Identified Aboriginal cultural assets and values

Please provide any comments you may have on the identified Aboriginal cultural assets and values on the floodplain.

Draft Billabong Creek Floodplain Management Plan

Figure 2. Proposed Floodway Network for the Billabong Creek floodplain

Attachment 1 – Site Boudnary and Waterways

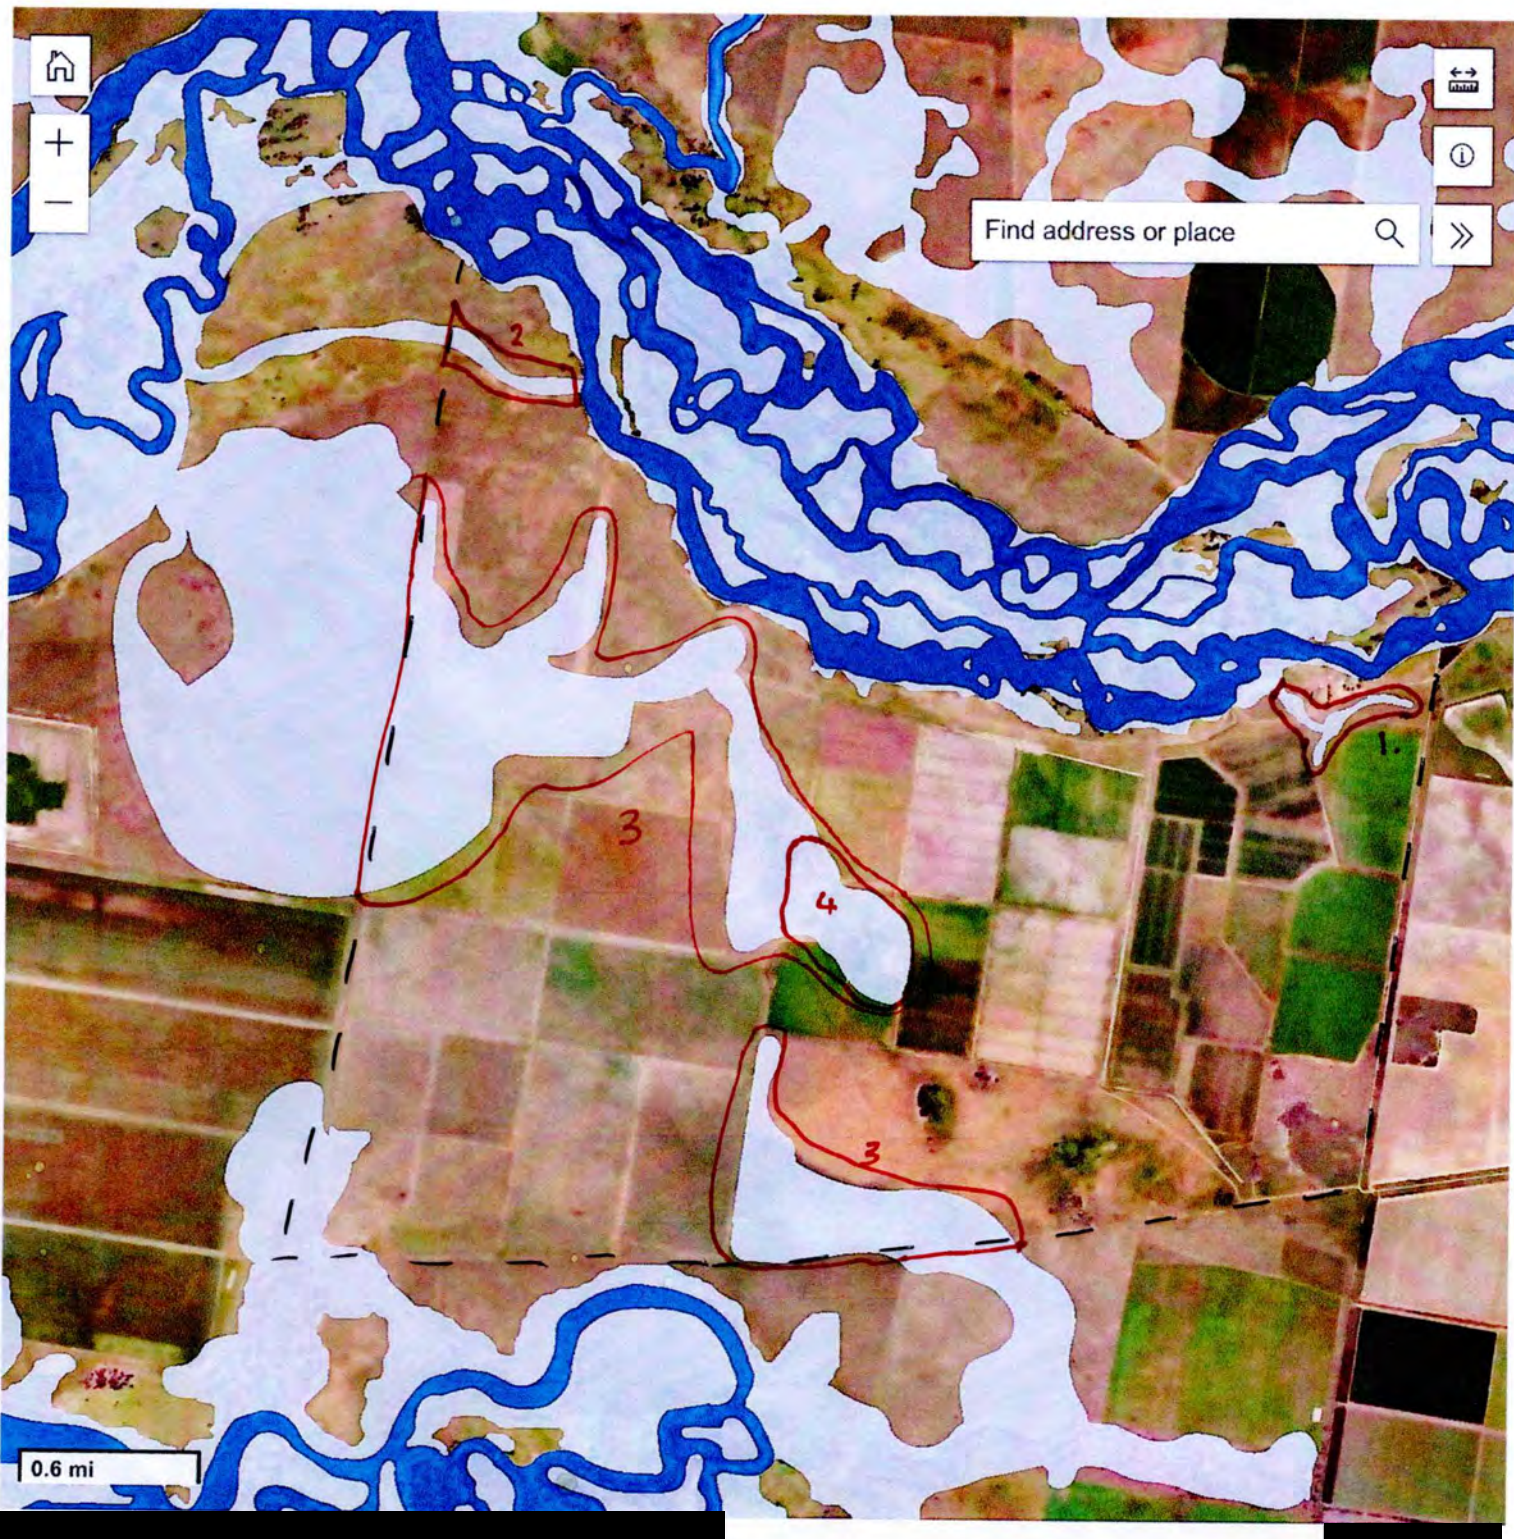
[2] gully - doesn't flood

[4] hollow which is rain filled only

[3] this is not inundation area low.

[1] irrigation recycle dam

* Please note 1. irrigation recycle dam. - It's not an inundation area

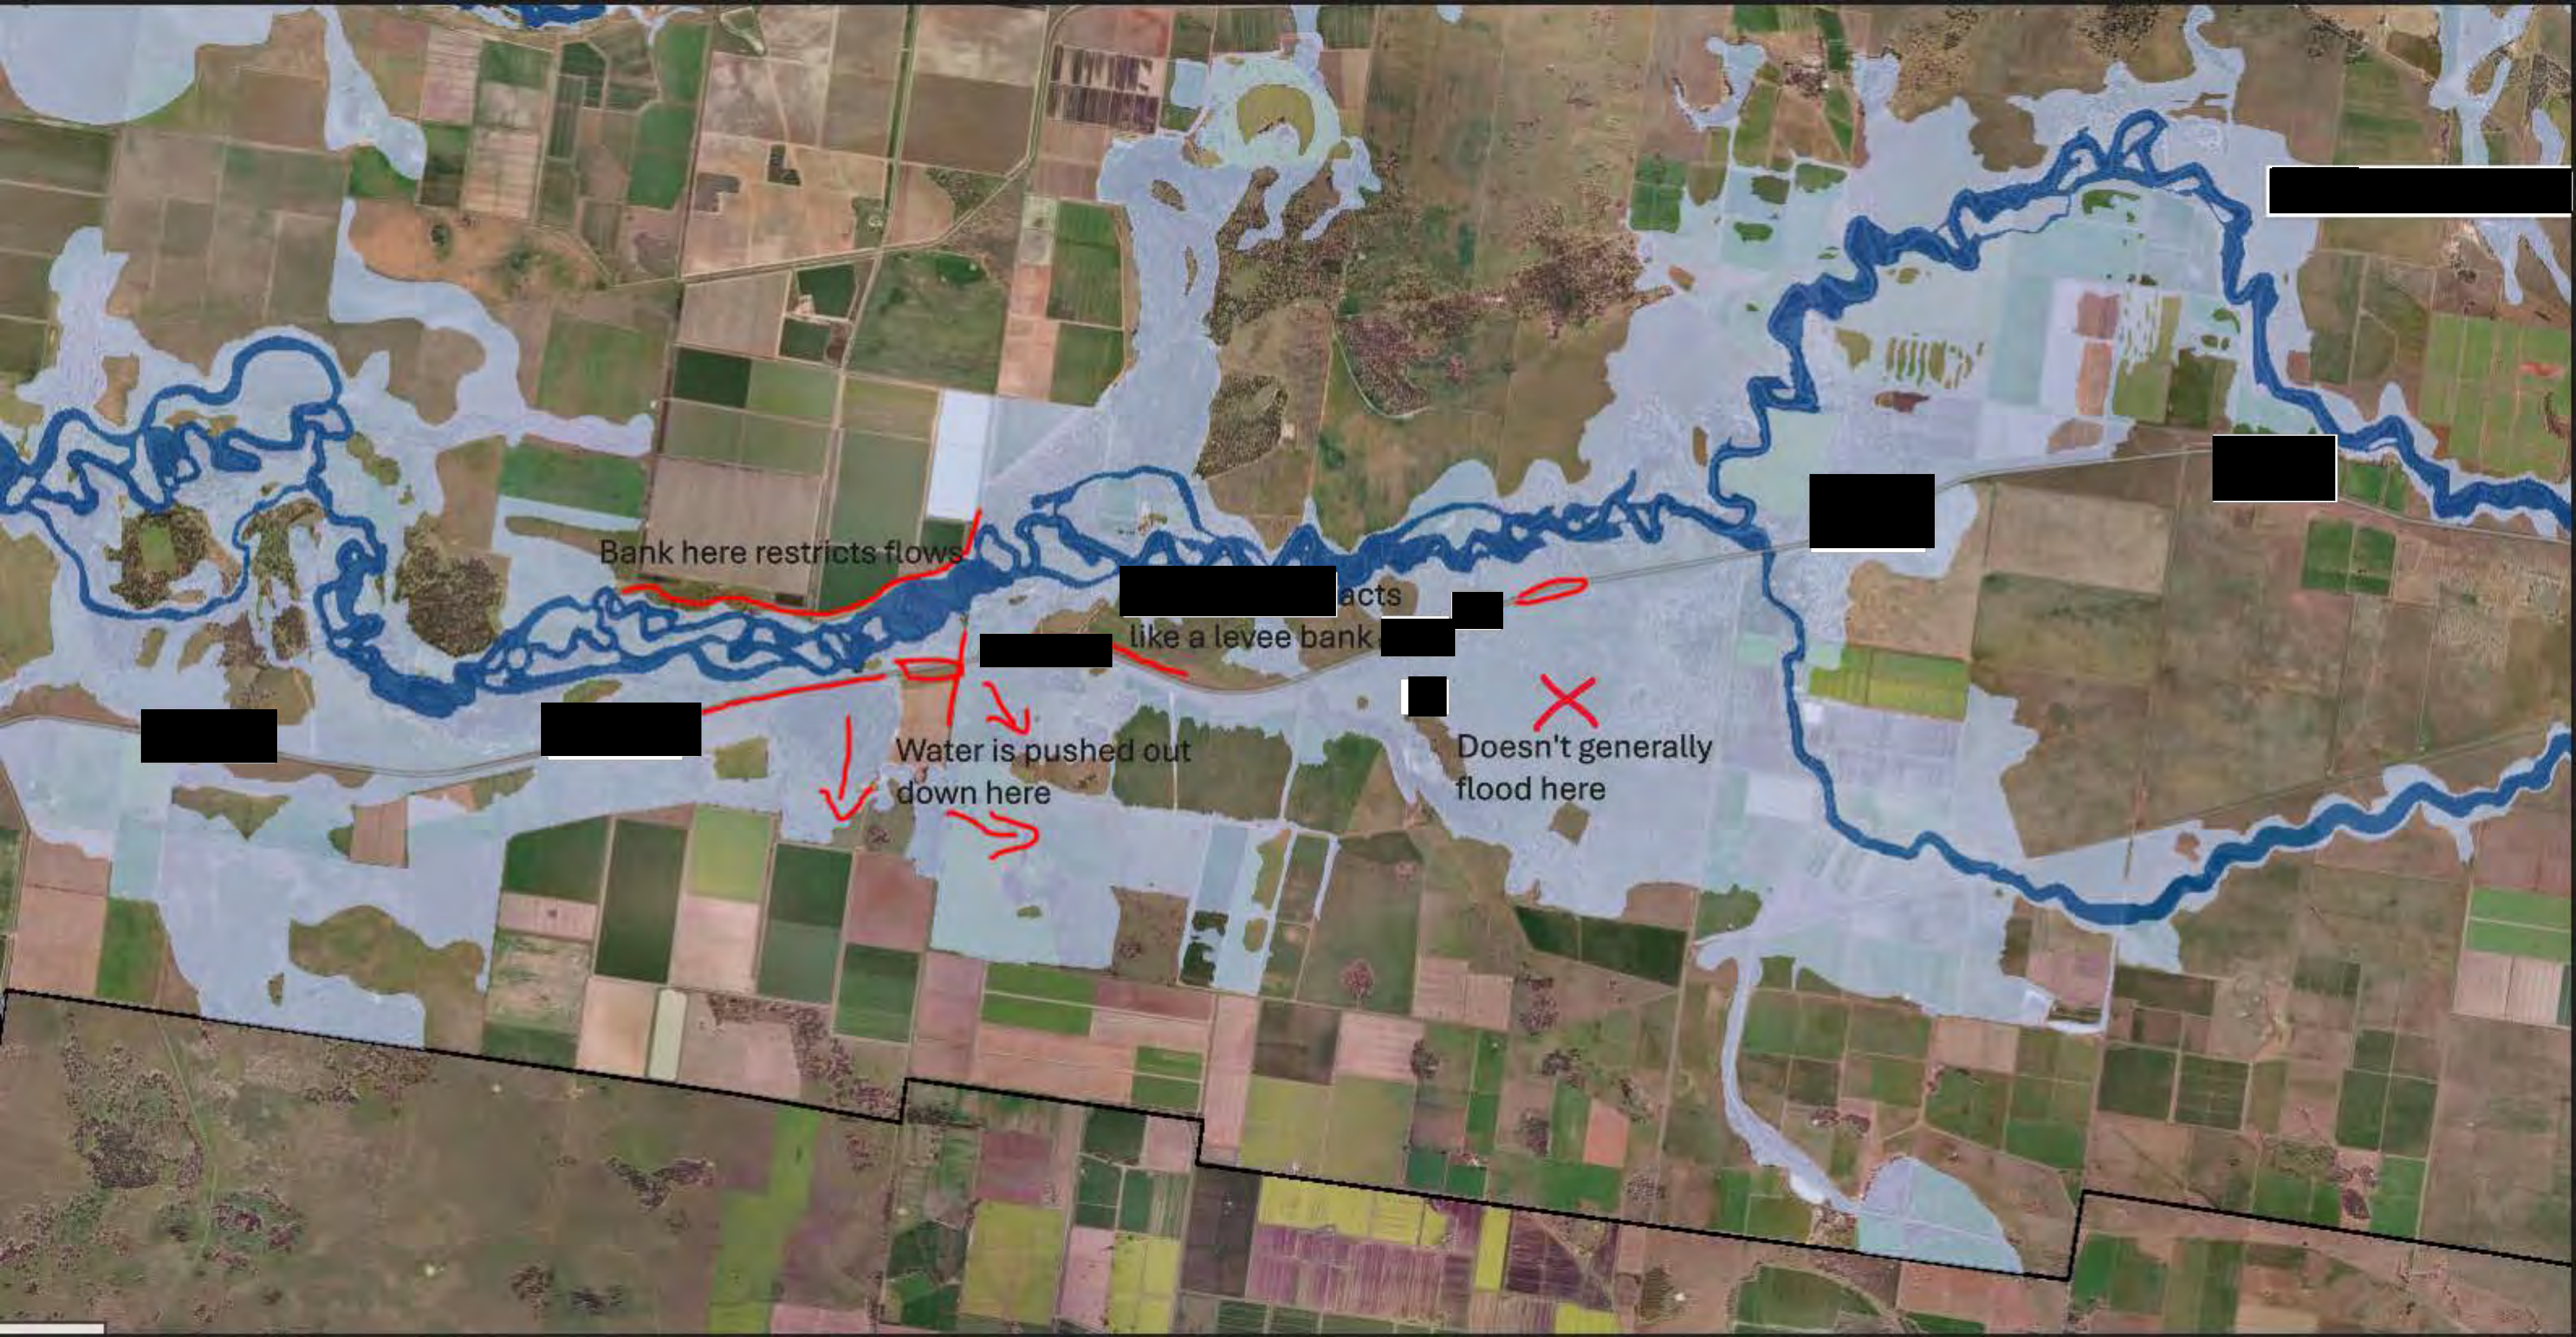
Bank here restricts flows

acts like a levee bank

Water is pushed out down here

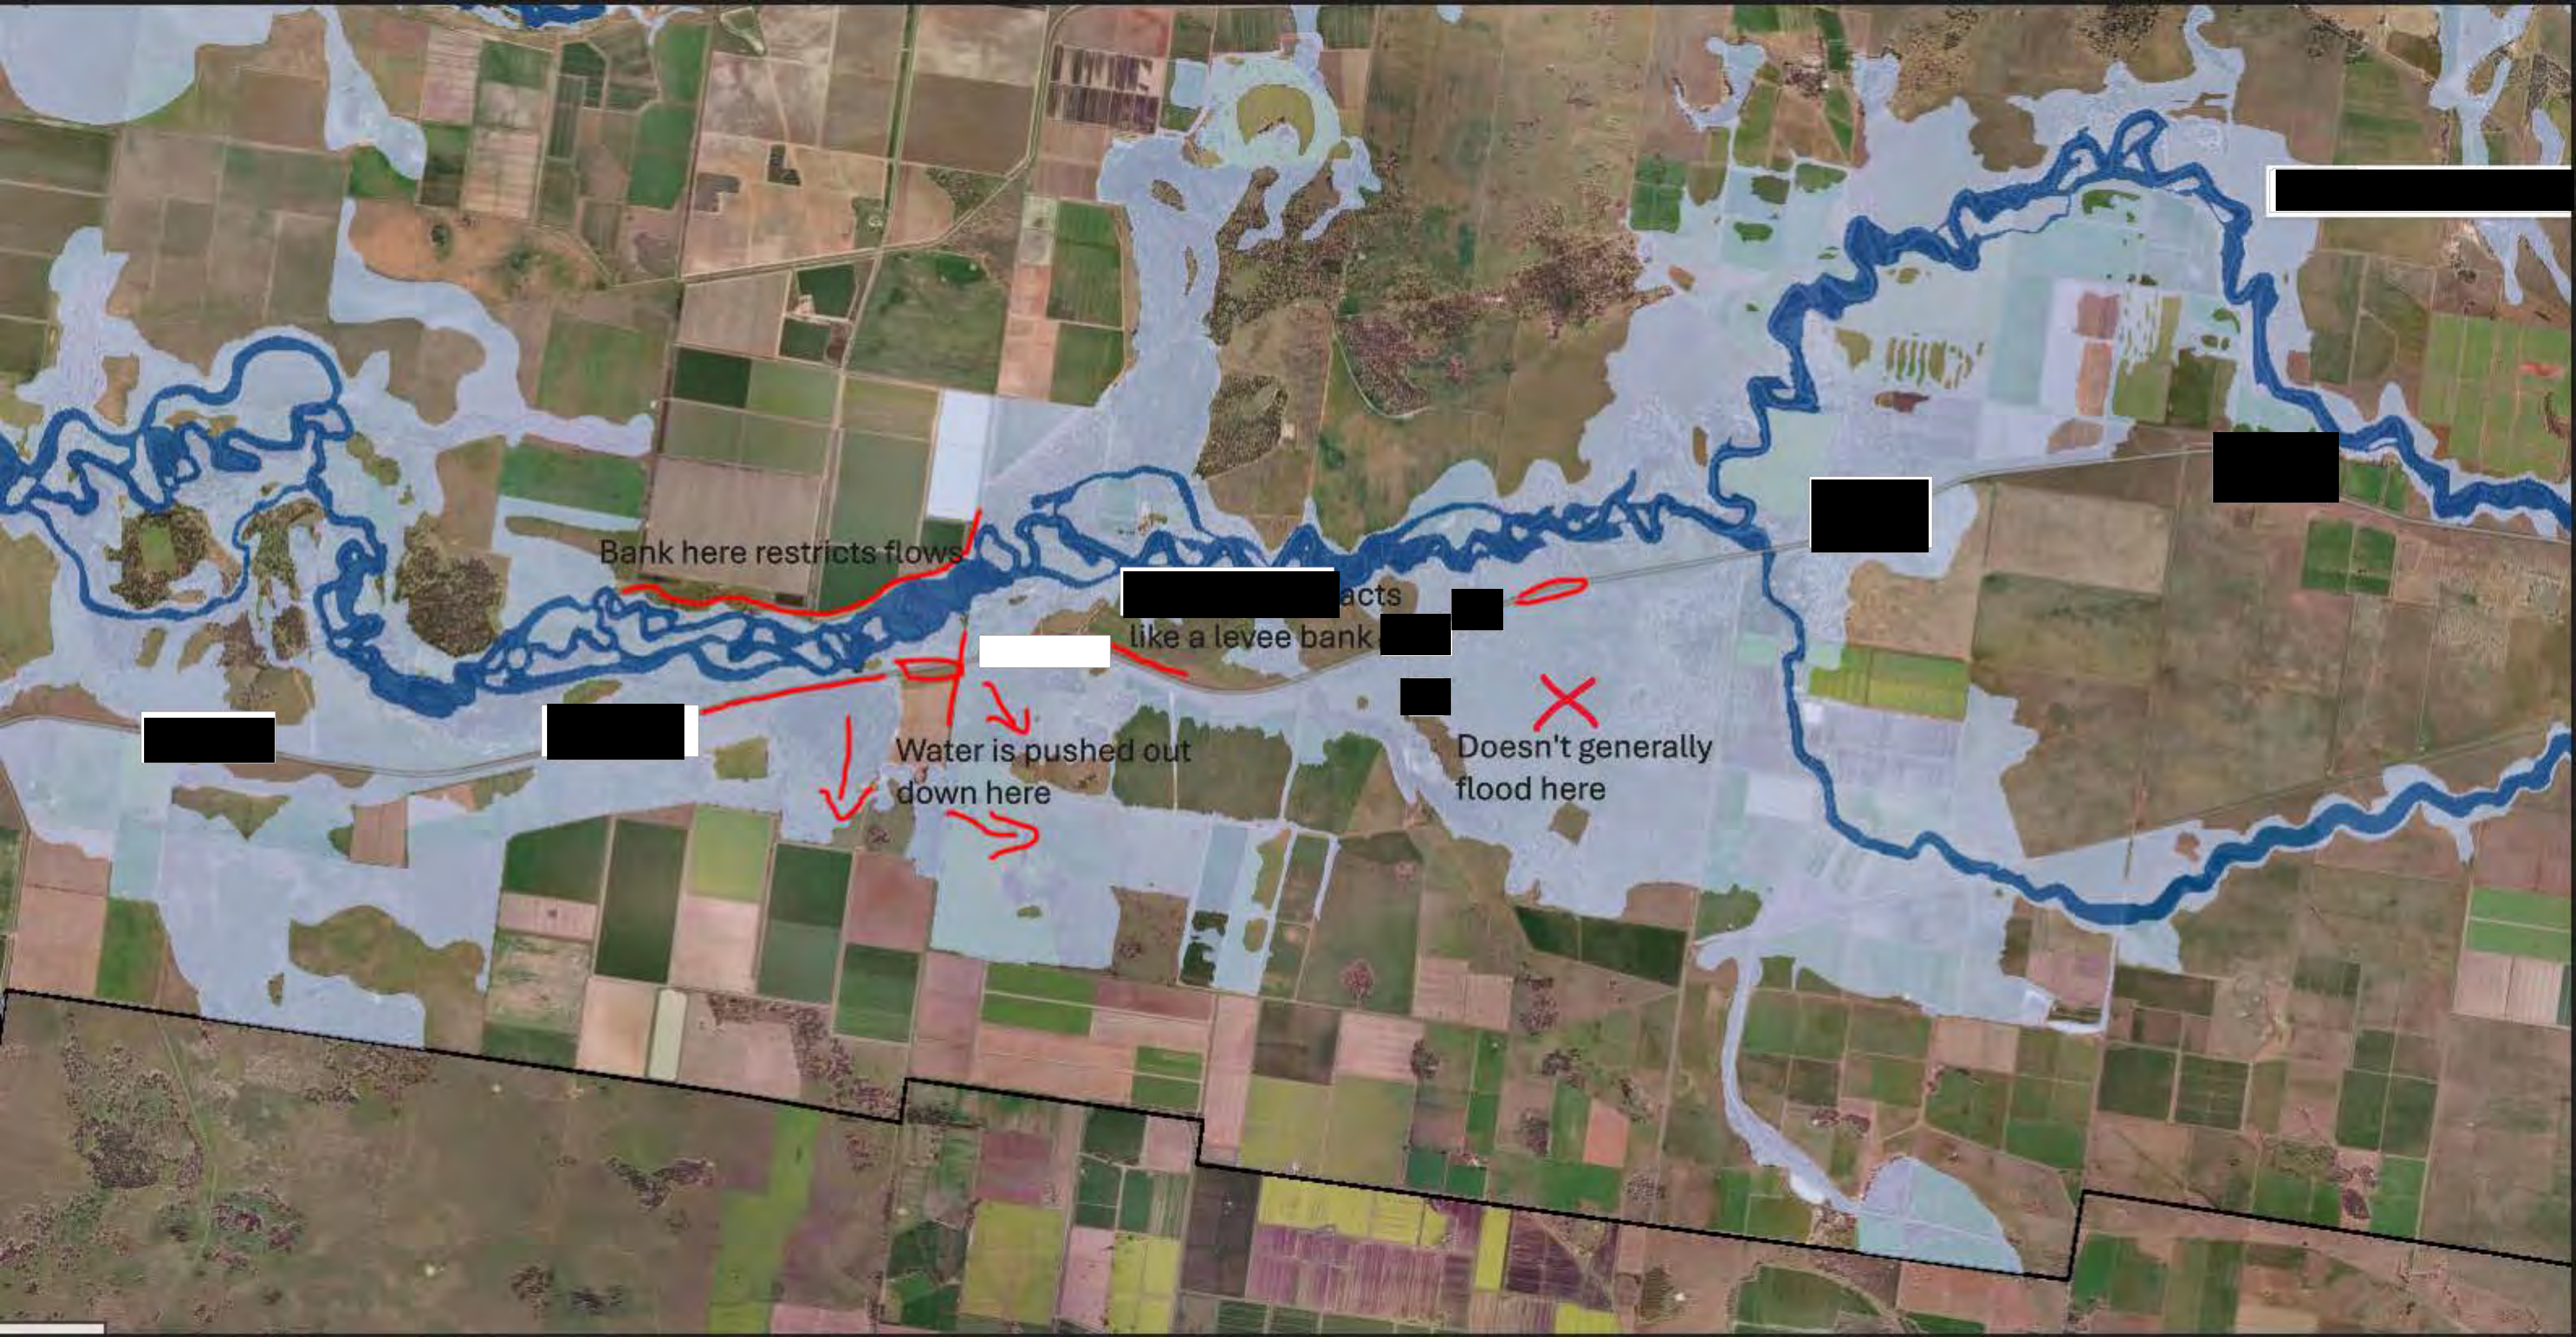
Doesn't generally flood here

Low point but not a wetland

Existing low
bank in the lake

Flood extent is wide
here near the

Does not flood here

Haven't heard of [redacted]
